MANDATORY SERVICE BULLETIN

No. MSB-E4-022/3
SUPERSEDES MSB-E4-022/2

Waste Gate Control Rod.

Engine type: E4
Engine model(s): E4, E4P
Serial number(s): all

Figure 4: Waste Gate Circlip

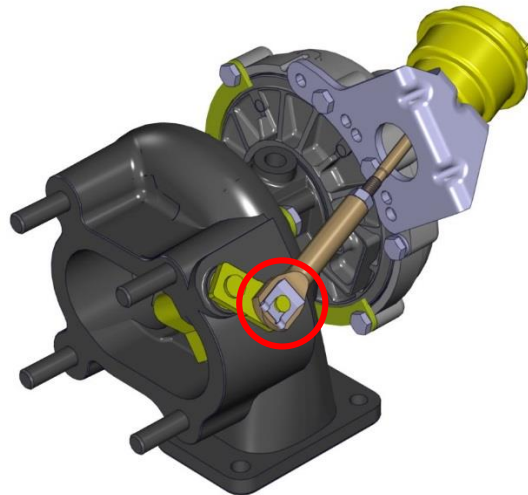
1. Make sure MM-TR-MDC-E4-386 and MM-TR-MDC-E4-399 are inserted into the Maintenance Manual or a revision of the Maintenance Manual with the Temporary Revisions incorporated is used.
2. Replace the waste gate controller according to Maintenance Manual section 81-00-33.
3. Install a new the spring loaded circlip E4A-41-100-801. Refer to figure 4

1. Replace the waste gate controller according to Maintenance Manual section 81-00-33.
2. Install a new the spring loaded circlip E4A-41-100-801. Refer to figure 4.

1. Make sure MM-TR-MDC-E4-422 is inserted into the Maintenance Manual or a revision of the Maintenance Manual with the Temporary Revisions incorporated is used.
2. If not yet installed, install a new spring loaded circlip E4A-41-100-801. Refer to figure 4.
3. Install the waste-gate con-rod fail-safe bridge according to Maintenance Manual section 81-00-36 or install a waste-gate controller with the fail-safe con-rod bridge already installed. Make sure there is sufficient clearance to adjacent parts.
